Process Sheet

Customer : CU-DAR001 Dart Helicopters Services
 Job Number : 32832 -3
 Estimate Number : 12812
 P.O. Number : N/A
 This Issue : 6/6/2007 S.O. No. : N/A
 Prsht Rev. : NC
 First Issue : N/A Type : MACHINED PARTS
 Previous Run : 32607
 Written By :
 Checked & Approved By : JF 07.06.07
 Comment : est rev A new issue 07.03.28 EC
 est rev B released, changed mat'l EC

Drawing Name : BRACKET

Part Number : D3610041
 Drawing Number : D3610 REV.A
 Project Number : N/A
 Drawing Revision : A
 Material : N/A
 Due Date : 6/30/2007

DESIGN <i>LE</i>	DRAWN BY <i>LE</i>	DART AEROSPACE LTD HAWKESBURY, ONTARIO, CANADA	
CHECKED <i>[Signature]</i>	APPROVED <i>[Signature]</i>	DRAWING NO. D3610	REV. A SHEET 1 OF 1
DATE 07.04.20	TITLE BRACKET		SCALE 2:3
REV A	DATE 07.04.20	DESCRIPTION NEW ISSUE

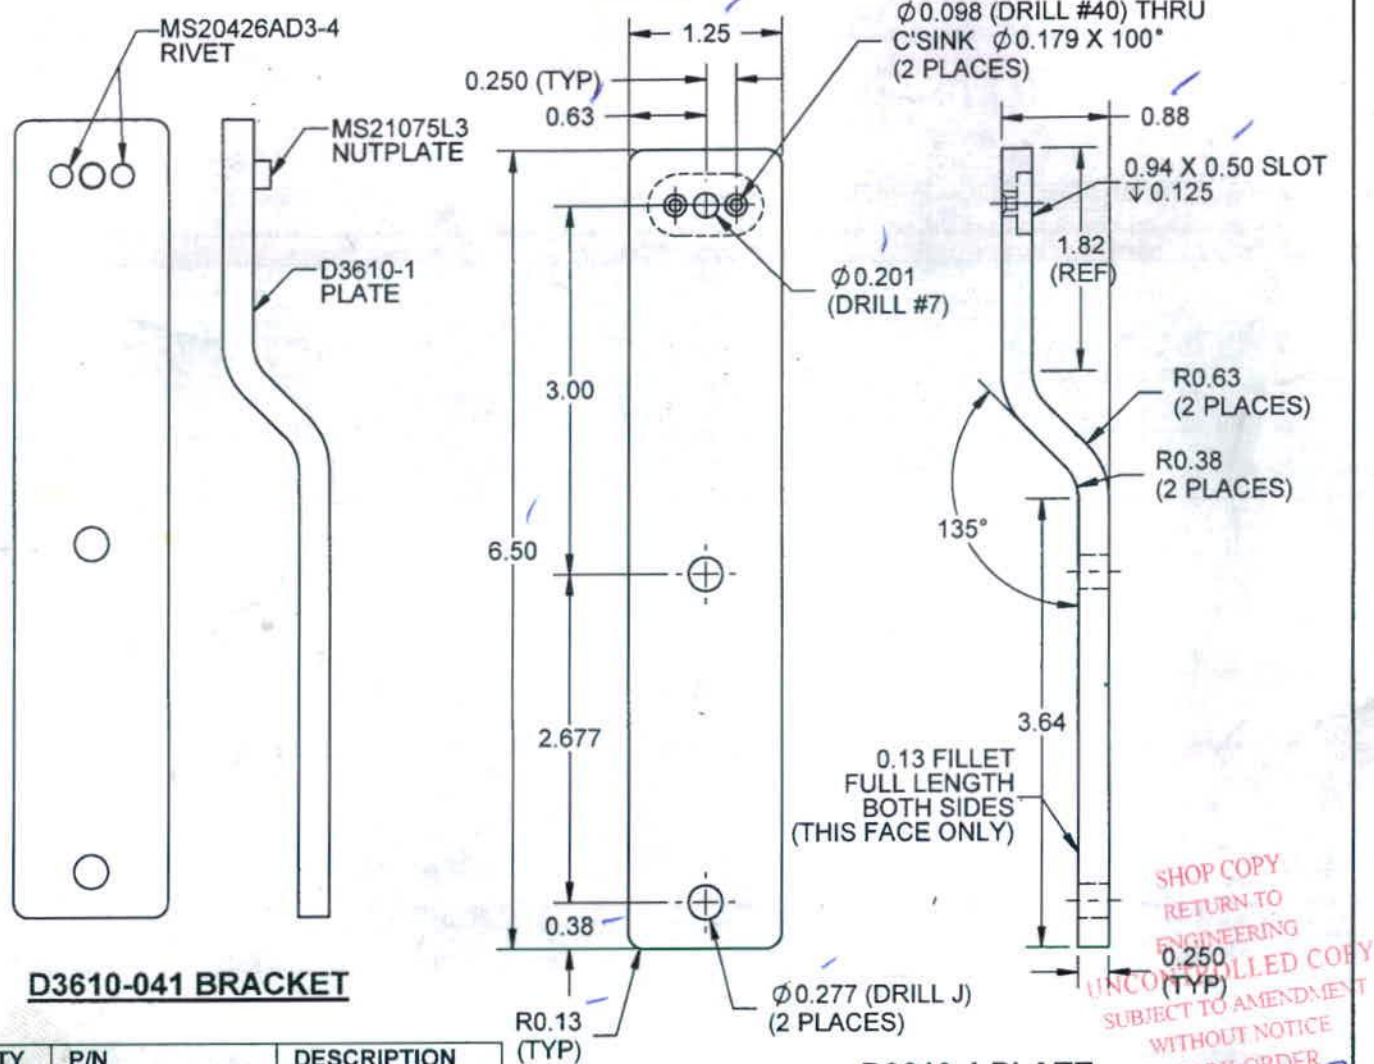
NCR: <u>32832</u>		WORK ORDER NON-CONFORMANCE (NCR)						
DATE	STEP	Description of NC Section A	Corrective Action Section B			Verification Section C	Approval Chief Eng	Approval QC Inspector
			Initial Chief Eng	Action Description Chief Eng	Sign & Date			
07/08/29	3.0	origin was slightly off, resulting in the holes being shifted over. 0.125". The holes were only spotted from the center drill, maximum 0.020" deep. L.C's origin was off, operator error	<i>[Signature]</i>	Fill & spot drilled holes with weld, per 031004, grind flush	<i>[Signature]</i> 07/08/29	<i>[Signature]</i>	<i>[Signature]</i>	<i>[Signature]</i> 07/08/29
07/08/29 07/09/01	3.0	one part scrap tool pulled out of holder part is 1.200 instead of 1.252	<i>[Signature]</i>	Scrap and replace and remove tool.	J.L. 07/08/29	<i>[Signature]</i>	<i>[Signature]</i>	<i>[Signature]</i> 07/08/29
07/09/03	3.0	1 part is scrap, the piece move when machining	<i>[Signature]</i>	Scrap, no replace	J.F. 07/09/03	<i>[Signature]</i>	<i>[Signature]</i>	<i>[Signature]</i>

NCR:		WORK ORDER NON-CONFORMANCE (NCR)						
DATE	STEP	Description of NC Section A	Corrective Action Section B			Verification Section C	Approval Chief Eng	Approval QC Inspector
			Initial Chief Eng	Action Description Chief Eng	Sign & Date			
07-09-04	3.0	1 st part was machined slightly too thick. R50, is 0.270". RCS origin slightly off. over set-up error.		Part acceptable. see e-mail.	N/A

Hi again. There was a D3610-041 bracket that the holes were only spot drilled, by a center drill bit, 0.025" in diameter, 0.020" deep, and positioned .144" off the center of the part, due to an incorrect origin. The material that is being machined is 4141 steel bar. What I had done, was the holes were filled with weld, buffed and then remachined. I don't see this changing the material temper. The part looks great. Is this acceptable to you?

Good morning, Leanne. There was one bracket the was machined too thick. The Dwg is 0.250" thick, and the part is 0.270". 0.010" over tolerance, is this acceptable?

I got a sketch from Leanne illustrating the problem.
Therefore, the repair you have outlined below is acceptable for this part.

Acceptable deviation.

This sounds fine to me.
